# Addendum to the 2017 Initial Study / Mitigated Negative Declaration

Covelo State Route 162 Corridor Multi-Purpose Trail, SCH No. 2017102051

Mendocino Council of Governments
19 January 2022

Figure 1

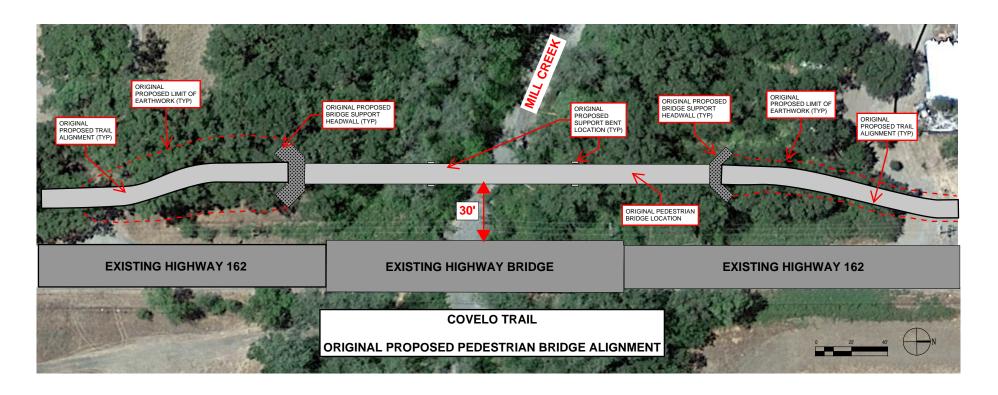
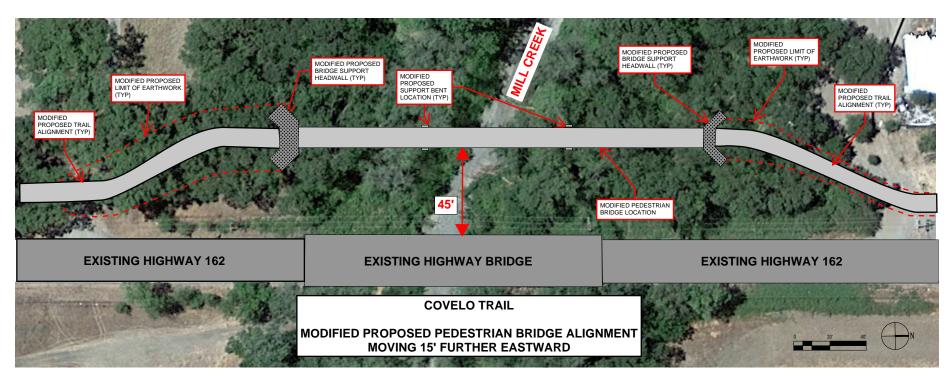
The bridge was originally designed to be approximately 30 feet east of the existing Caltrans Highway bridge to allow for clearance from the existing bridge, existing power lines, and an existing buried sewer force main operated by Indian Health Services (IHS) to serve nearby tribal facilities. The location of the sewer force main and hence the offset from the existing bridge was based on the IHS design drawings. The original CEQA document was based on this alignment. However, following completion of the CEQA process, IHS made it known that their design drawings were not accurate and in fact the force main was further east, potentially putting it under the proposed pile foundations for the bridge. Therefore, it is necessary to move the bridge further eastward away from the force main.

A modified bridge alignment moved 15 feet to the east is proposed to provide sufficient clearance from the force main. Mill Creek is of uniform cross section in the vicinity of the bridge and hence the bridge concept is the same as originally proposed, but simply moved 15 feet to the east. The new location will require slightly modified approaches to the bridge and a slightly modified footprint (Figure 1).

As a result of the updated bridge alignment over Mill Creek, vegetation impacts are anticipated to be moved to the east and slightly increased due to the slightly longer bridge approaches needed to join with the modified bridge location (Figure 1). However, the riparian vegetation in the area of the bridge is generally uniform and therefore the nature of the potential impacts is anticipated to be similar to those analyzed in the 2017 ISMND.
